SEWAGE DISPOSAL SYSTEM

HOWARD COUNTY HEALTH DEPARTMENT

SUBDIVISION Hyde Property LOT 15 ROAD 12291 Scaggsville Road

PLOT PLAN

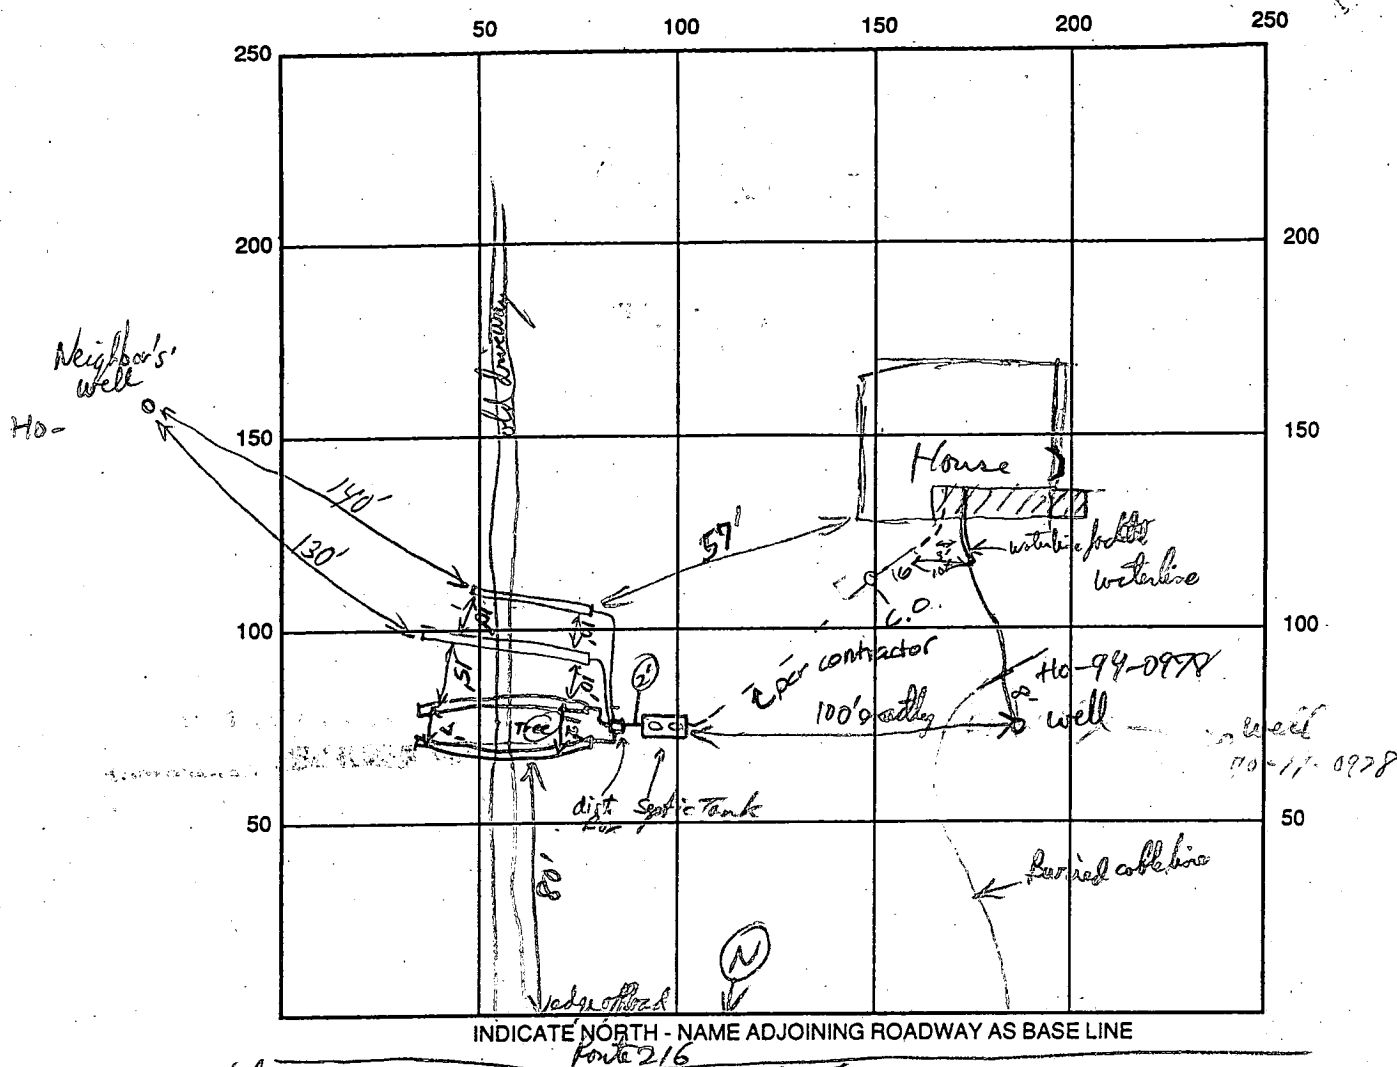
4/7/96 waterline not properly sealed, broken & leaks R/P. C Ken Feaga is Plumber
4/30/98 waterline jacket sealed OK - Needs water test for House Connection

REMARKS: OK to crew let 2 trenches but keep 10 ft center to center spacing (begin & end @ 8 ft center)
but 2 trenches OK to crew. Needs House Connection & Needs Monhole & riser on Septic Tank,
Not demand pipe since Septic Tank is 4 ft below grade. R/P 3/11/98 4/3/98 C.O. # end of line
observed near the house ALL Monhole & Risers on Septic Tank are OK. R/P 4/6/98
House Connection is Not observable - Needs a water test or expose line for inspection. R/P 4/6/98

W/P waterline is less than 10 ft (min 3 or 4 ft) from Septic line near House Connection and is unprotected - provide a water
tight jacket on waterline within 10 ft of Septic line. R/P 4/6/98 Water test is OK R/P 4/6/98 water line jacket OK 4/30/98
DATE SYSTEM APPROVED 6/9/98 INSPECTOR Ann Mc Miller

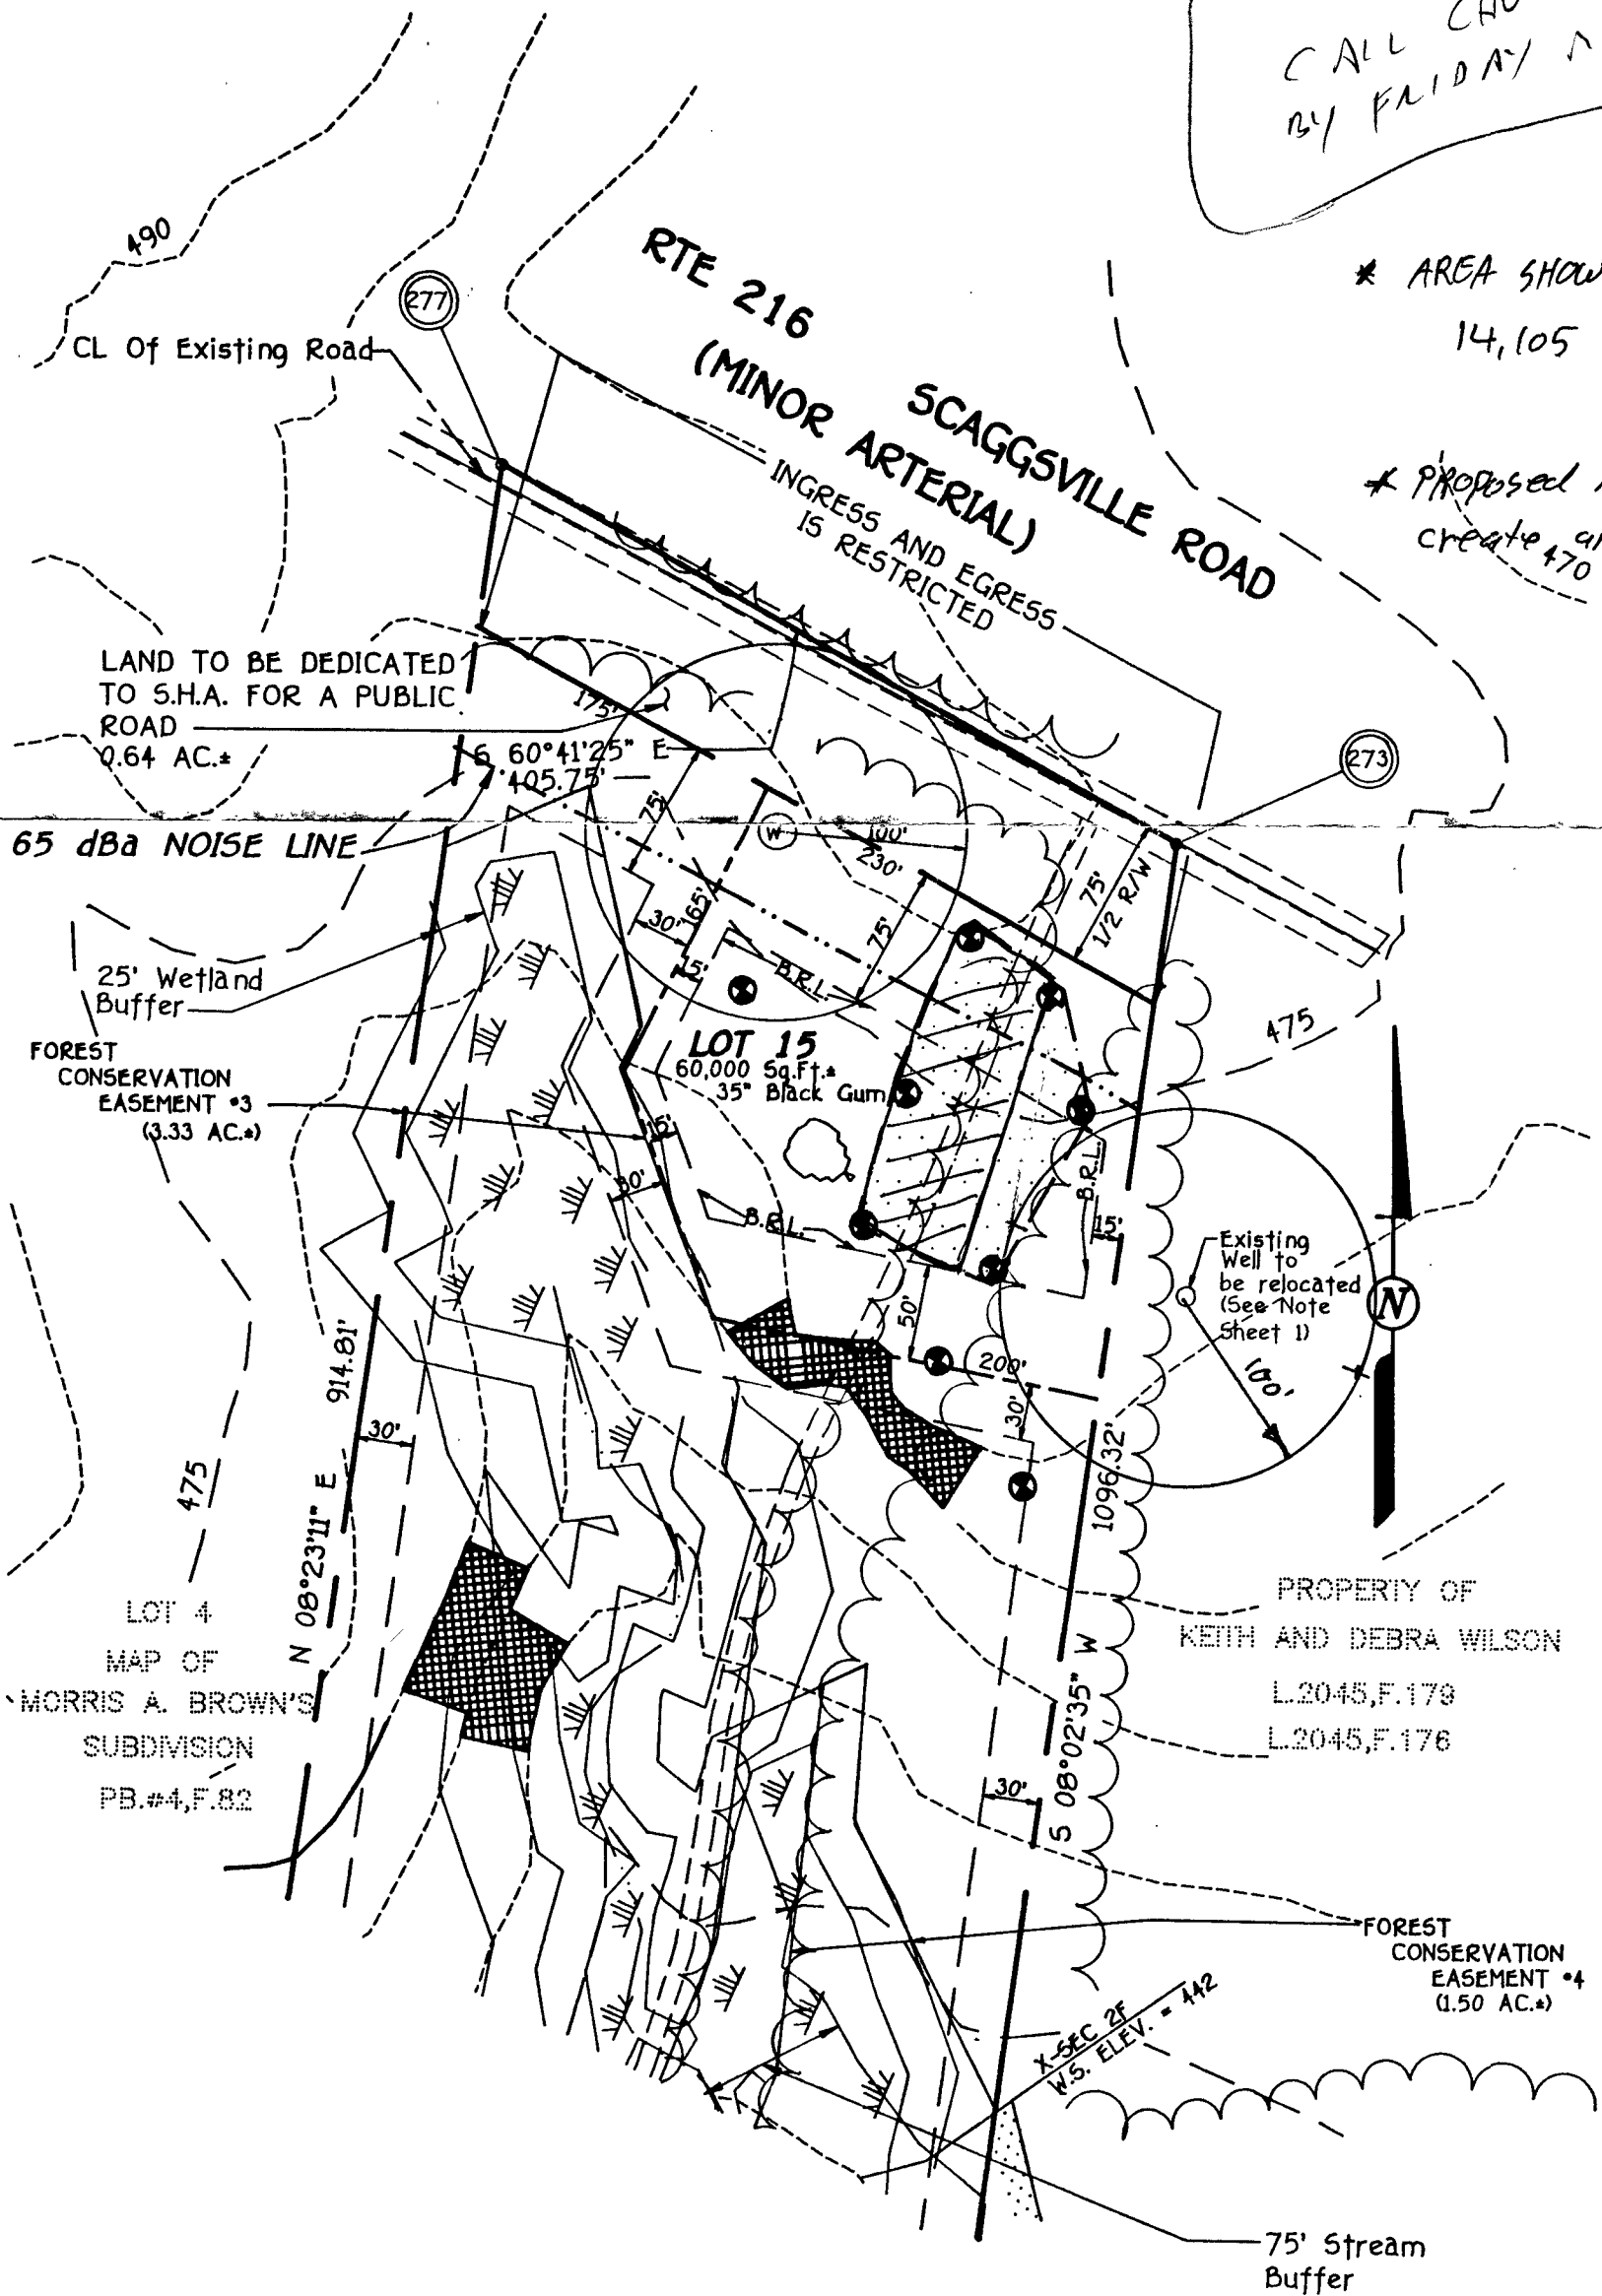
800109451
See the when B Regal came in — 4 Bdr Plan came in — with driveway
taking sharp Turns to stay off SDA only problems are ① Dist box is only 93 ft from well.
② they show House connection + Septic tank inverts 2 ft above existing ground level.

Although Septic tank is less than 100 ft (i.e. @ 75 ft), if water tight
(i.e. Top Seamed) S.T. is used this would be preferable still than one where top of
Tank would be 2 1/2 ft above grade. Dist. to Drain Field will be at
preferred location. Do we need a written request for this
waiver of well & S.T. separation Distana? 1/15/98 RFP

RG: HYDE LOT 15 -

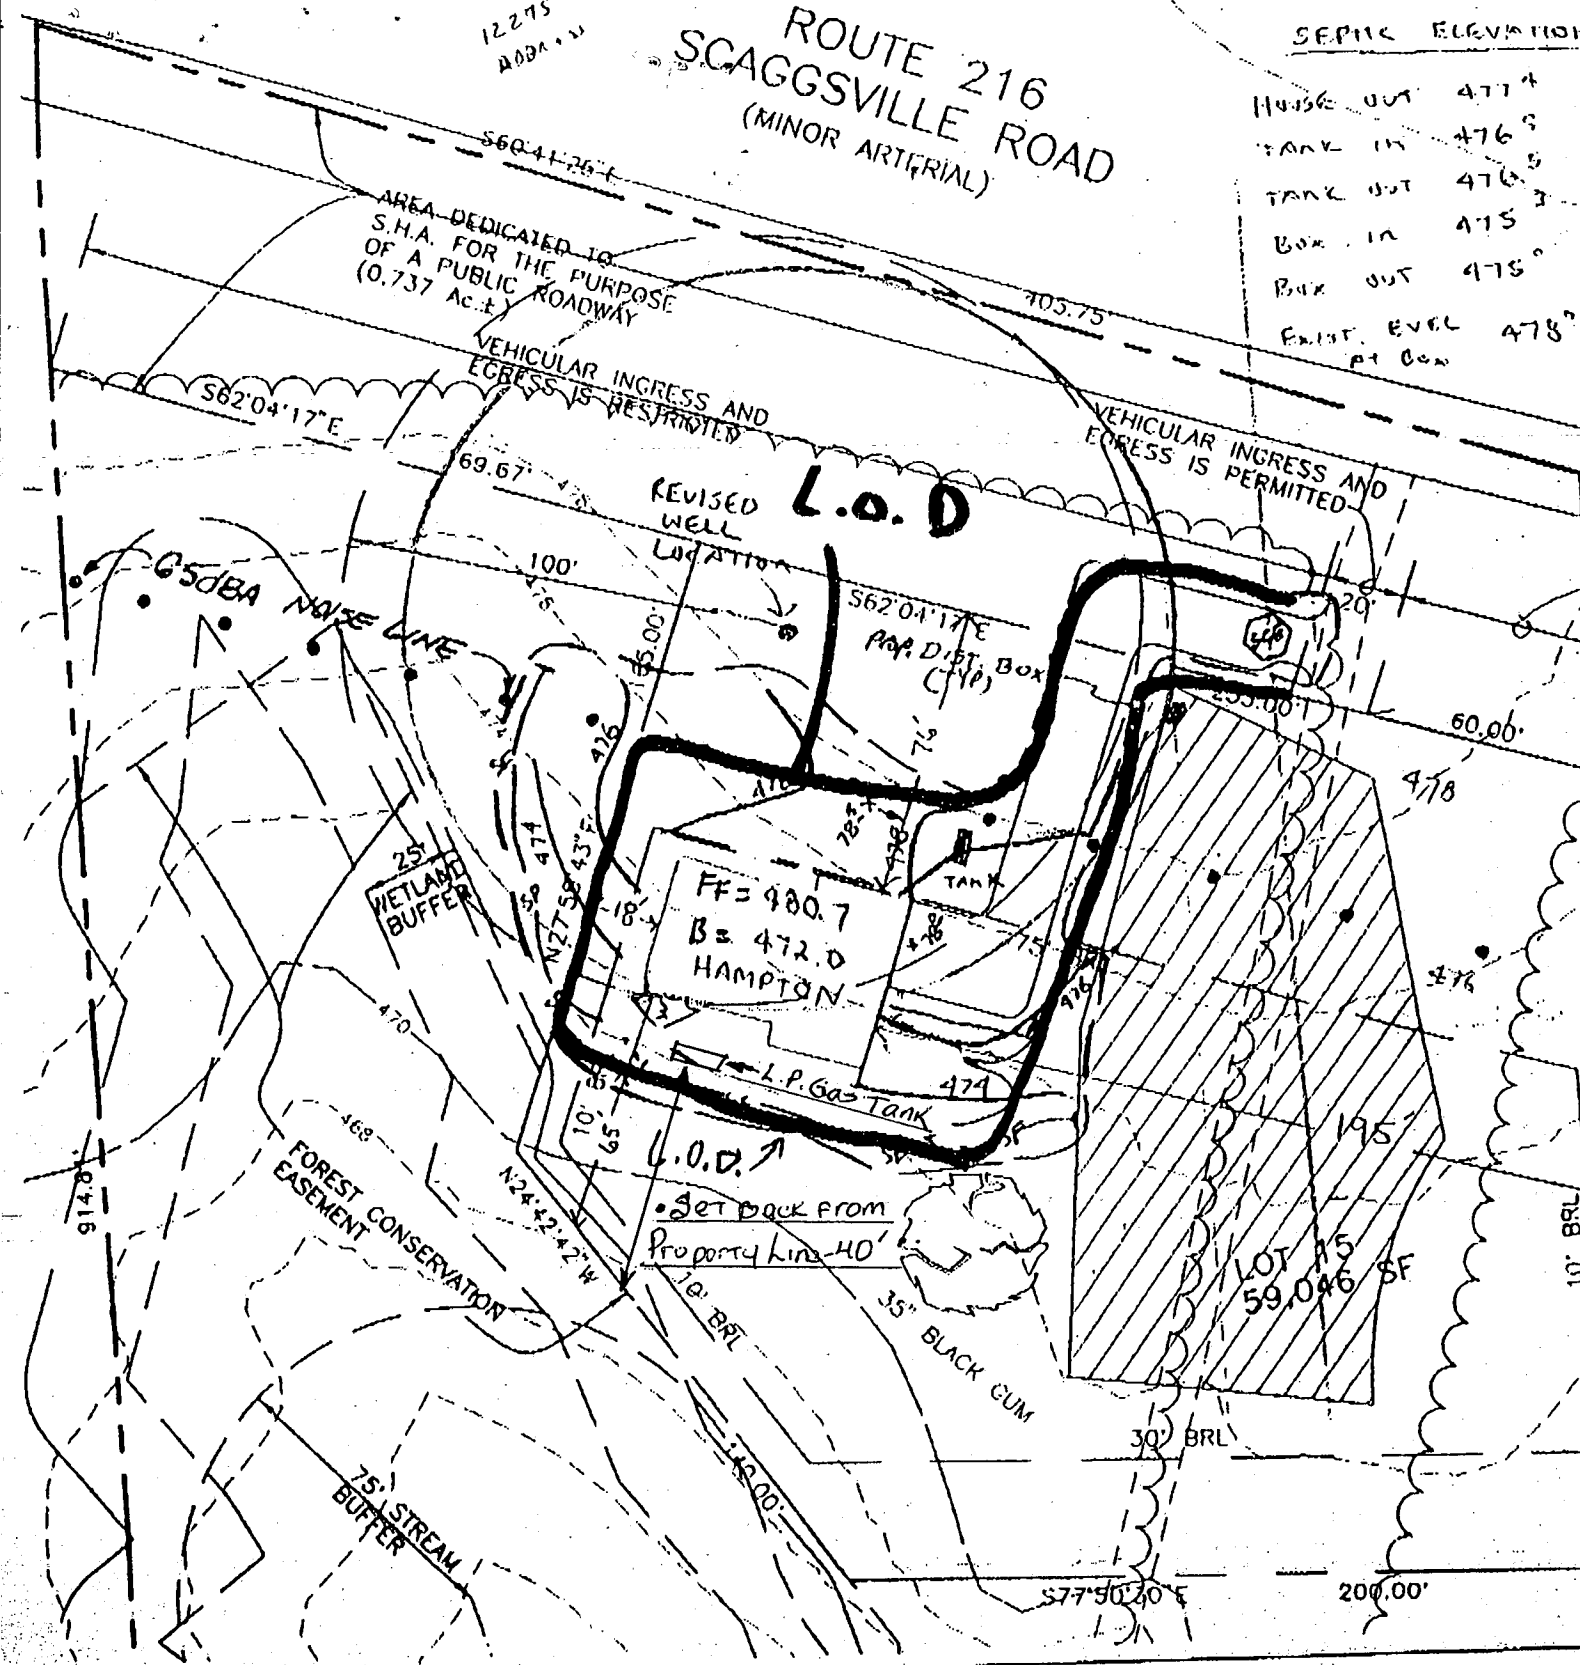
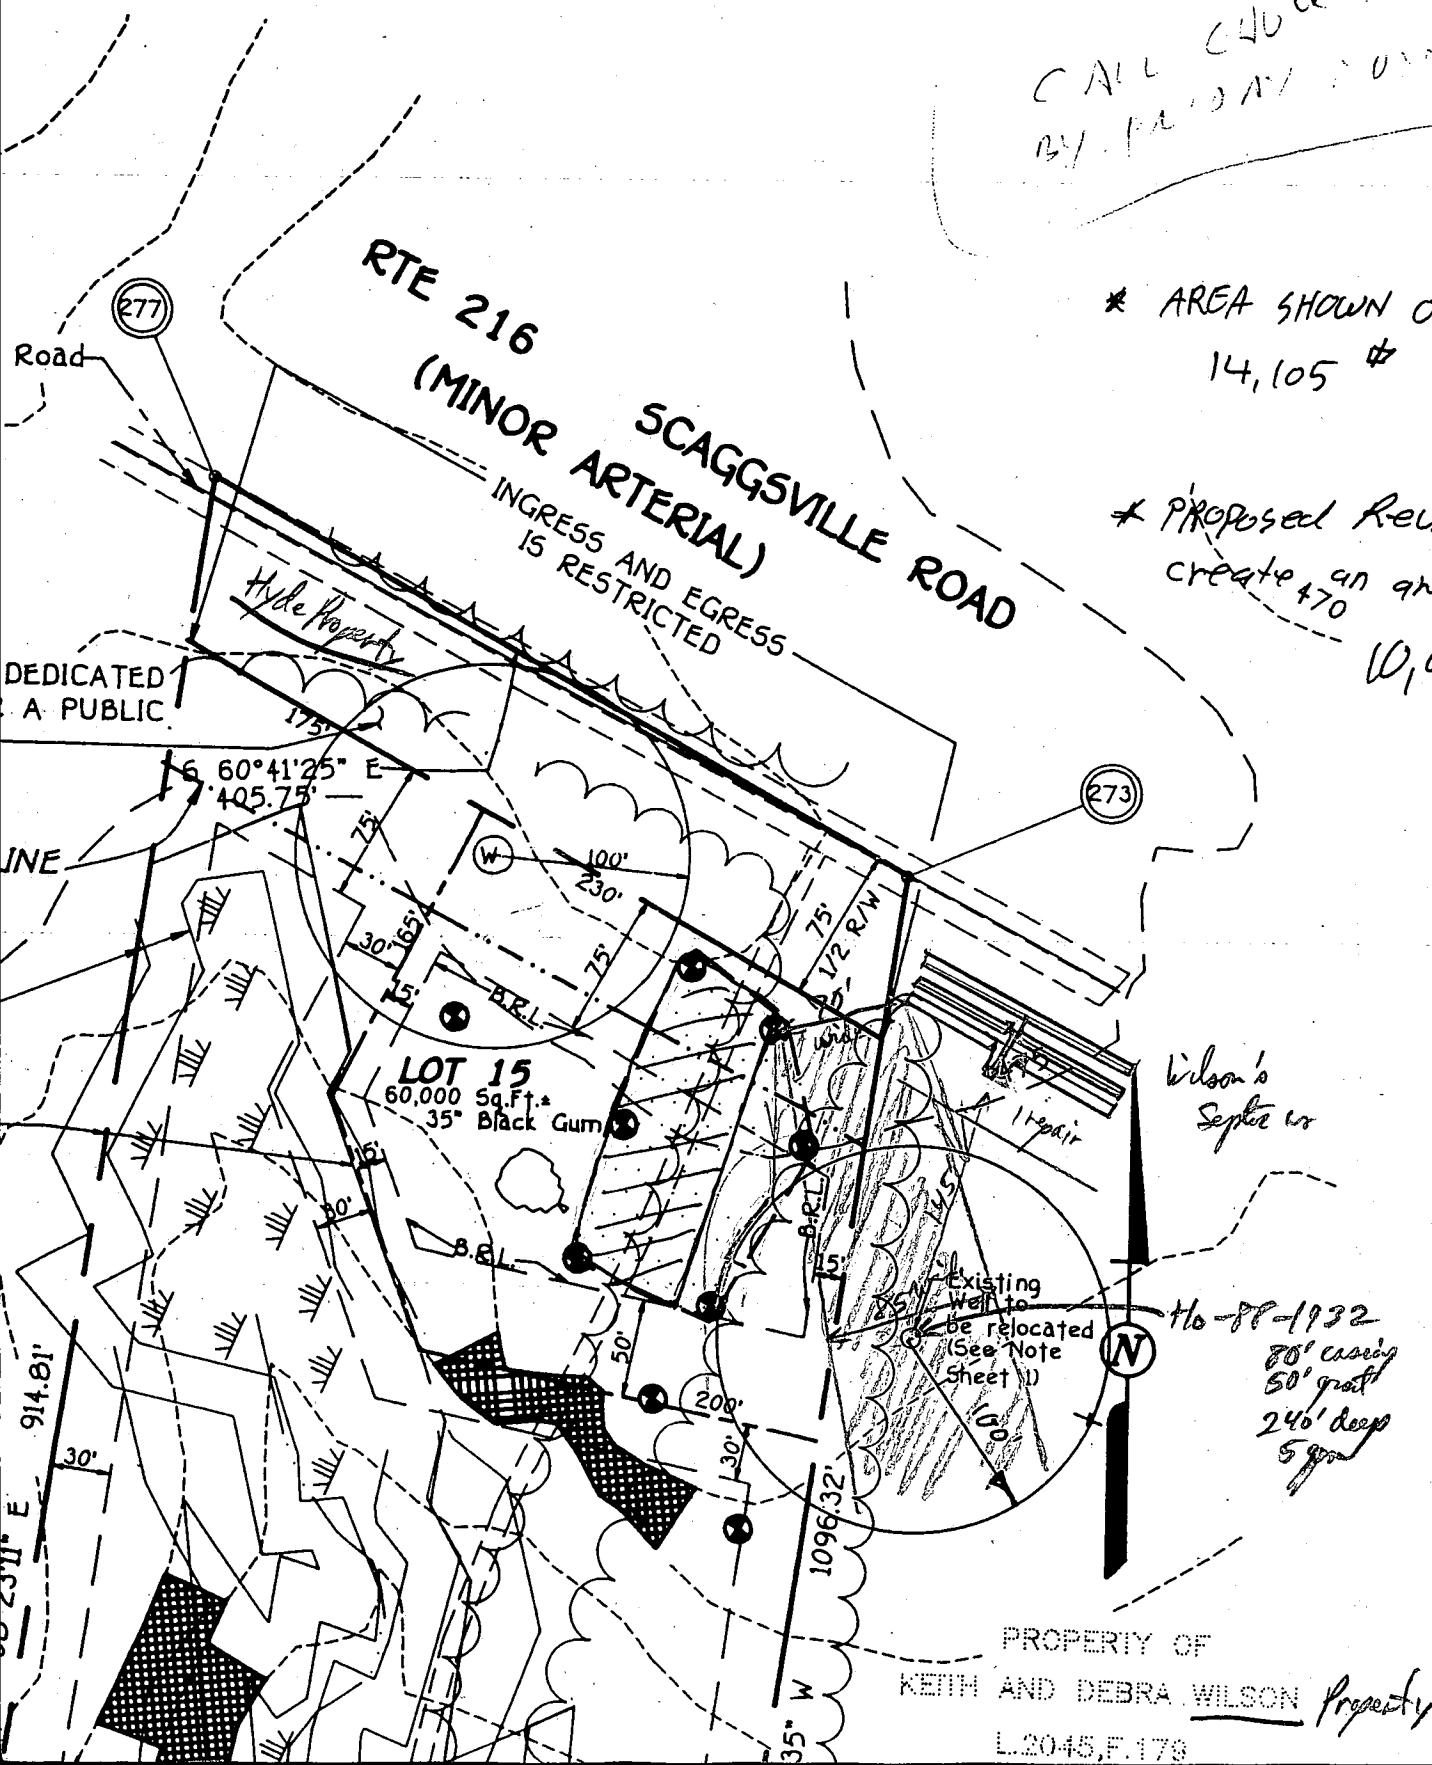
although Septic tank is less than 100 ft (i.e. 75 ft), if water tight
(i.e. Top Seamed) S.T. is used this would be preferable still than one where top of
Tank would be 2 1/2 ft above grade, Dist. to Dr. & Drain Field will be at
preferred location. Do we need a written request for this
waiver of well to S.T. separation distance? 4/15/88 Rft

* AREA SHOWN ON THIS XEROX
14,105 #

* PROPOSED REV. WILL
create an area of
10,000 #
